Subject: License Amendment Application
NRC License No.: 37-00282-04
Docket No.: 030-05986
Dear Sir or Madam:

SmithKline Beecham Pharmaceuticals d/b/a GlaxoSmithKline wishes to amend its byproduct material Nuclear Regulatory Commission license to reflect a change in item 9, Attachment 9E (Waste Management) in our license application of 2003. These changes do not change the scope of our license.

RADIOACTIVE LOW LEVEL WASTE STORAGE BUILDING

RADIOACTIVE LOW LEVEL WASTE STORAGE BUILDING Revision 1 (4-14-2005)

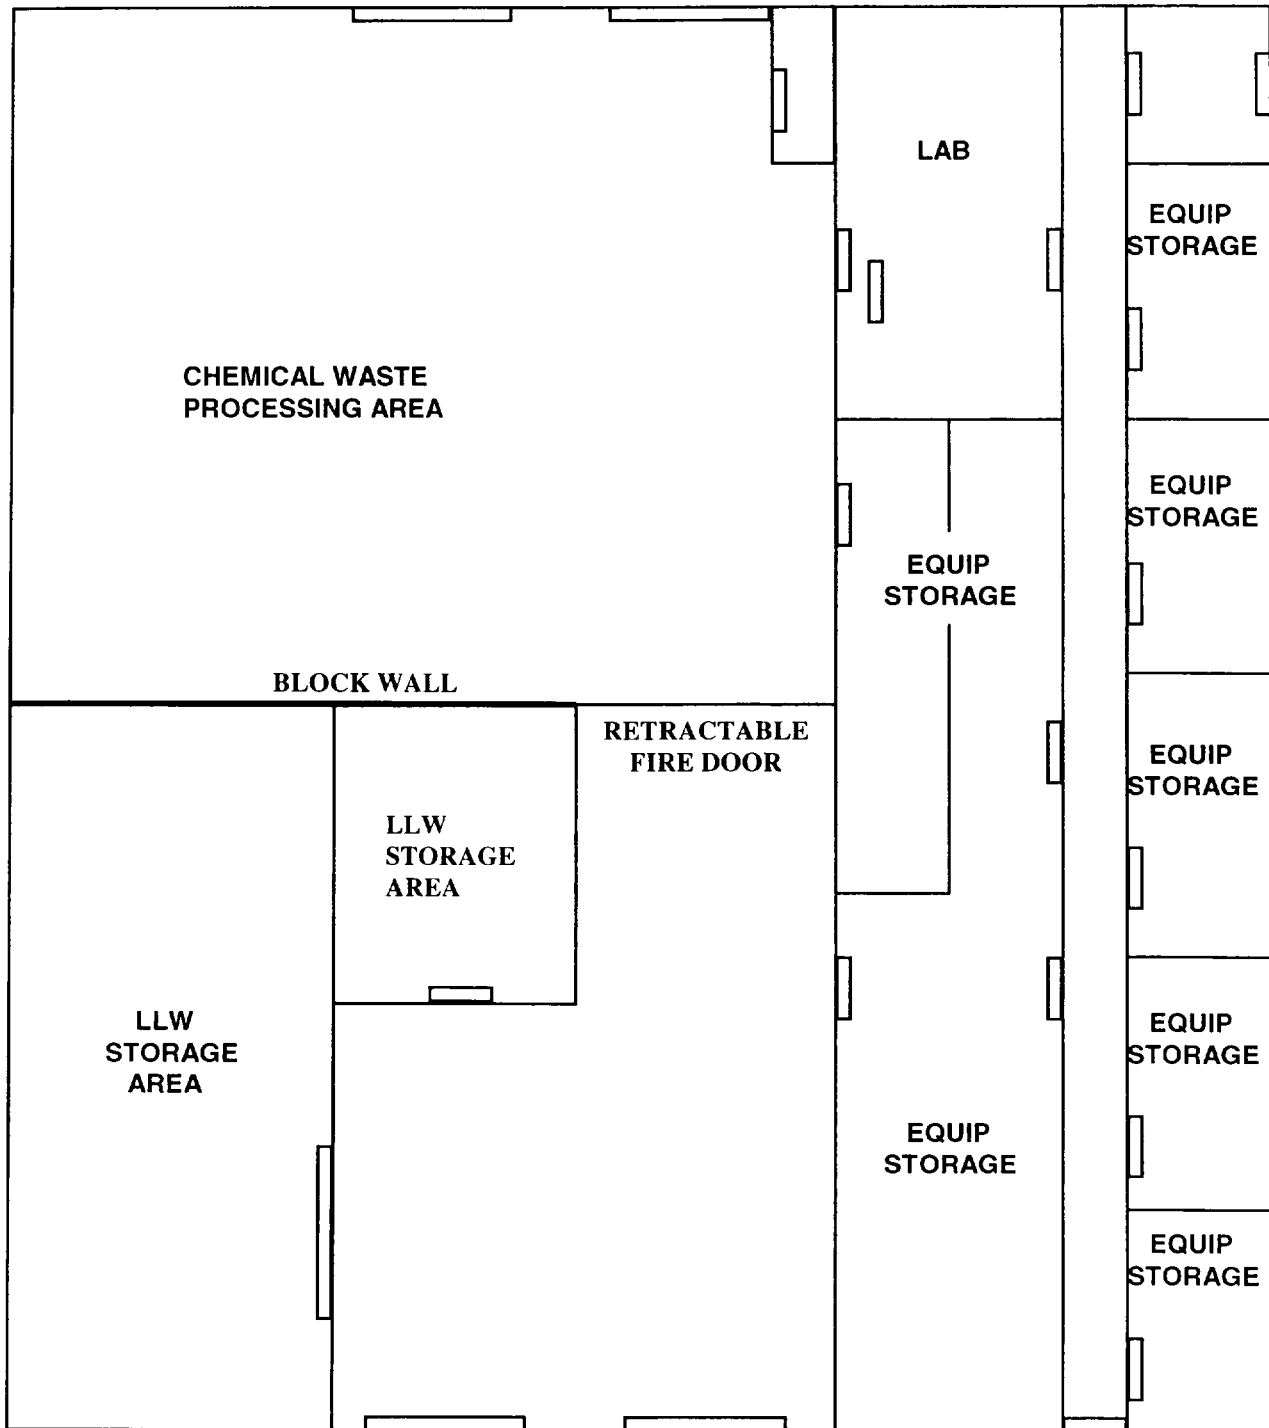
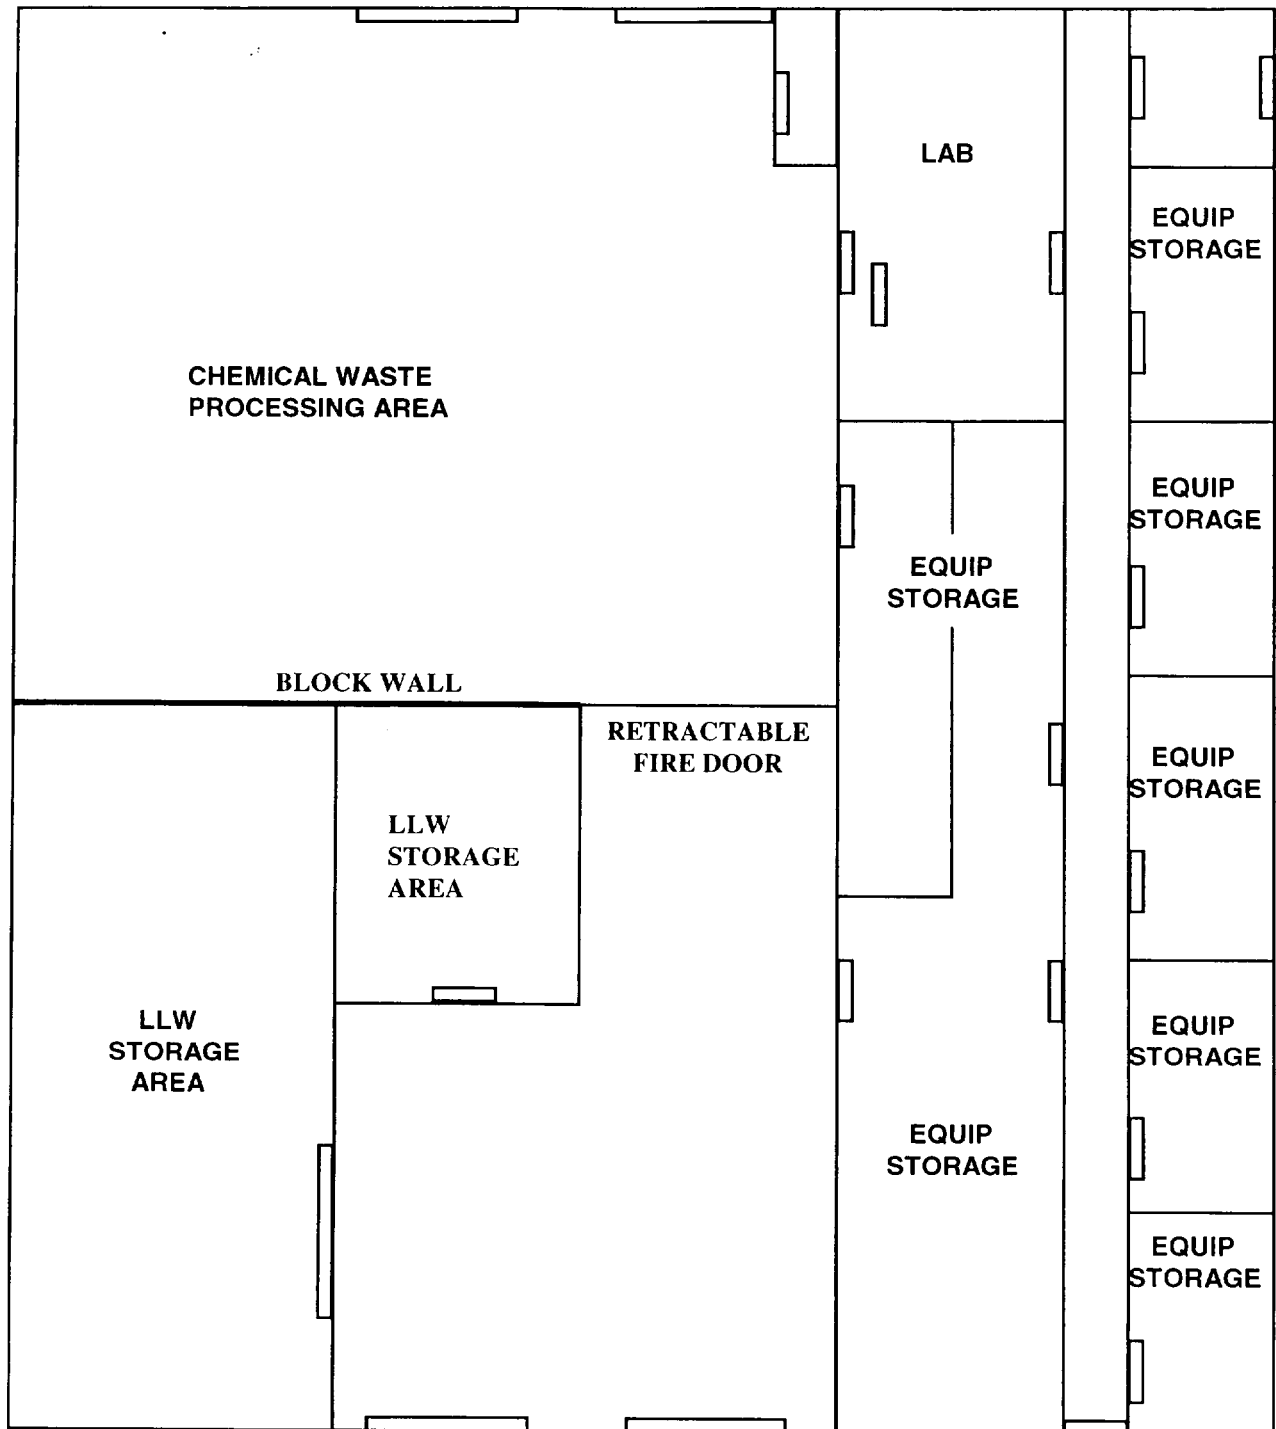
We are removing a cold storage trailer (a refrigerated sea-van) that formerly housed radioactive carcasses for decay in storage as referenced in section 9 (page 11 and Appendix 9E) and section 11 (page 25).

Attached is a copy of the old schematic for building 35 Low Level Waste storage area found in Appendix 9E of our 2003 license application as well as a copy of the new revised schematic. We have removed the cold storage trailer from the revised schematic.
